## ADDENDUM 2

**Date:** February 20, 2015  
**Project:** Waterfront Park PIAP Improvements  
**To:** All bidders  
**From:** BPRW Project Coordinator, Jon Adams-Kollitz

WATERFRONT PARK UPGRADES  
Utility Plan

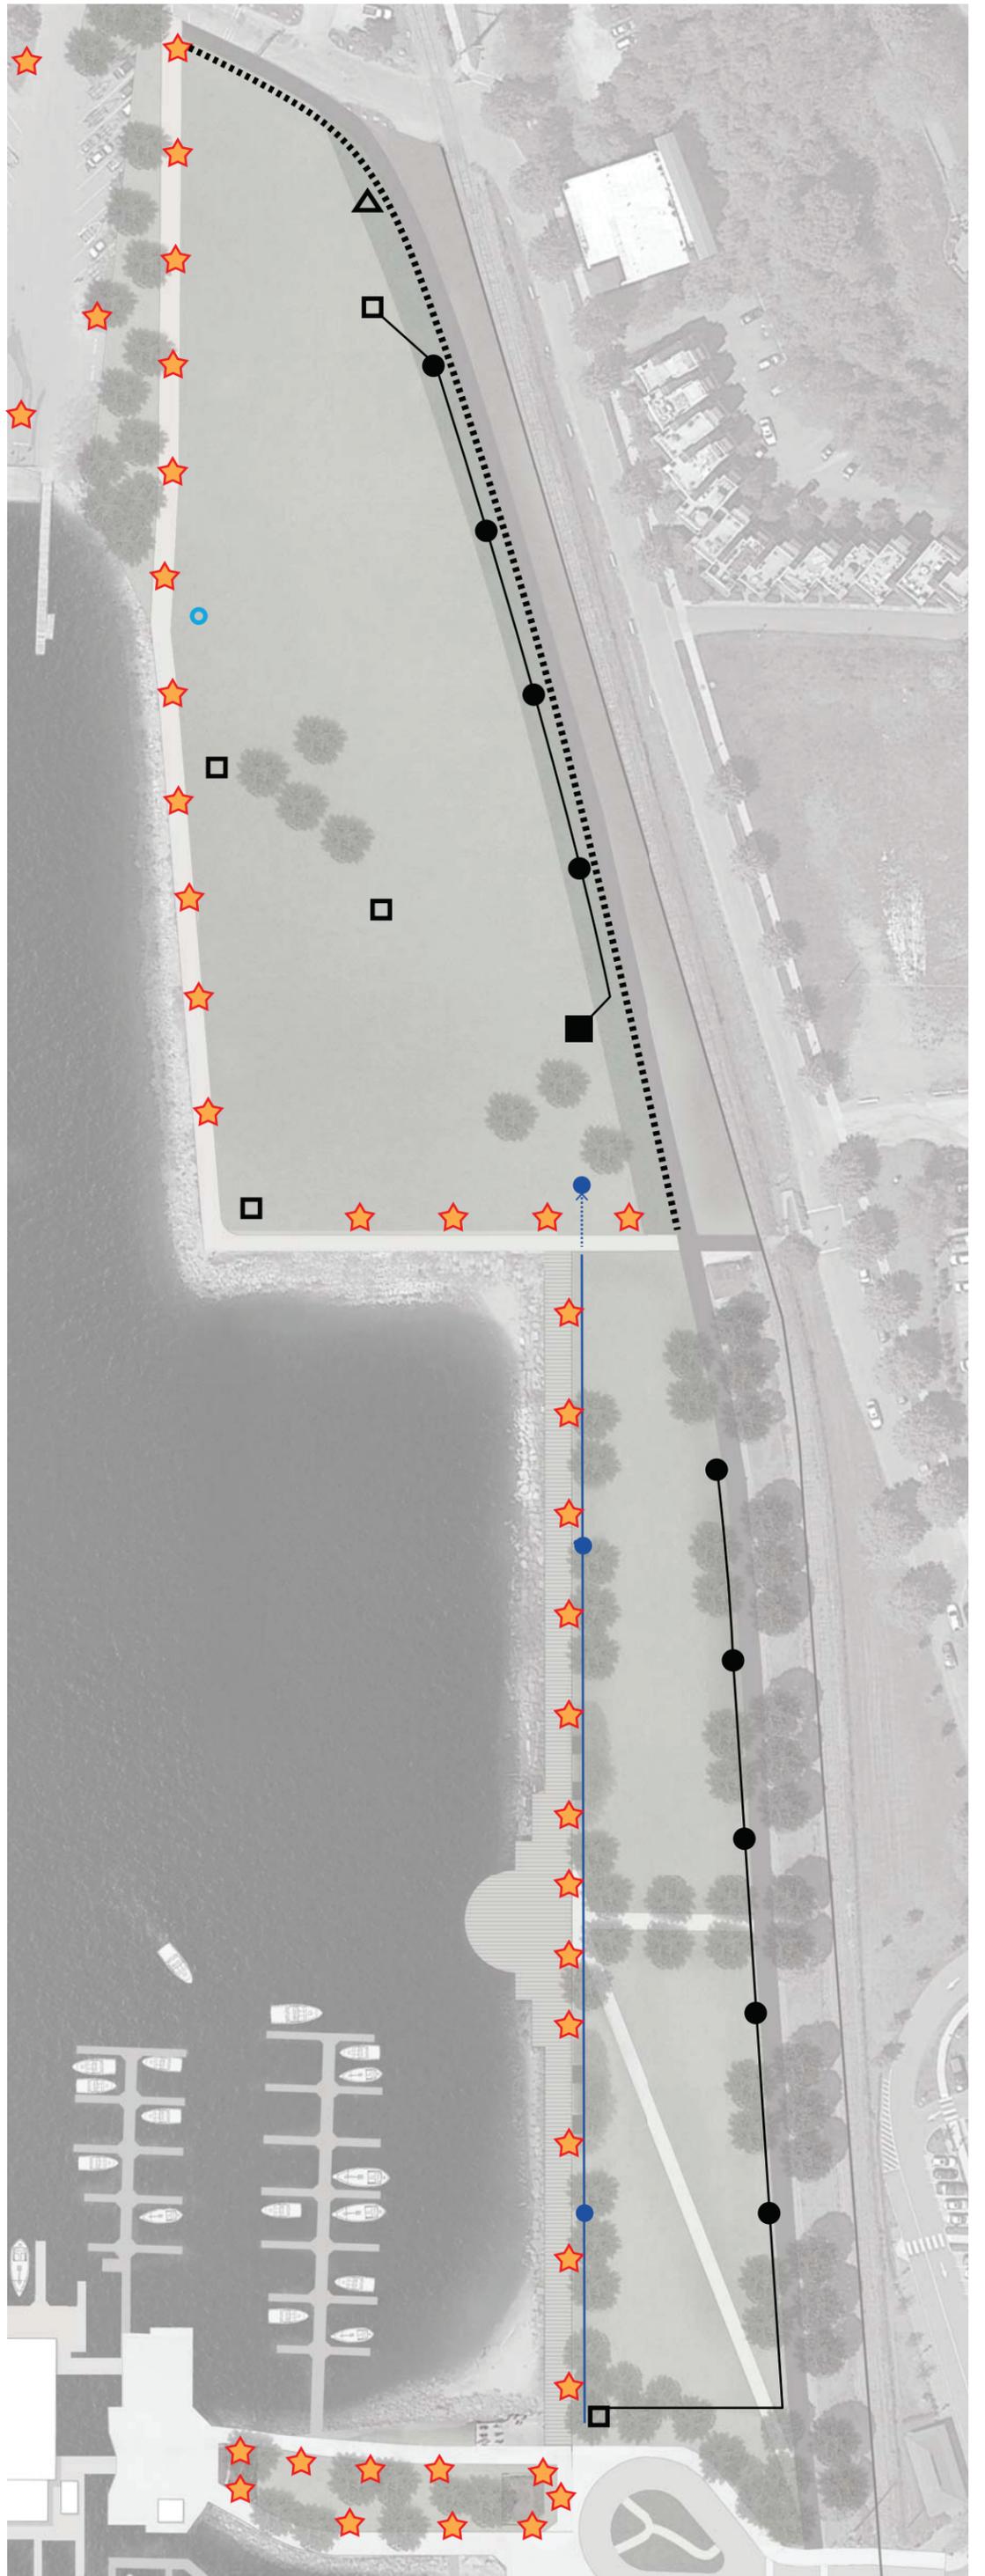
2. On the sketch labelled UTILITY PLAN power pedestals are shown along the east boundary. On the plan of lighting and power the power on the east side is labelled FUTURE. What is required?

**The utility concept plan (attached & dated 20131216) is the direction we will be moving towards, which shows power bollards along the eastern boundary. This is a conceptual representation of what we are looking for in terms of bollard location and quantity that will be fleshed out during the upcoming design process included in this scope.**
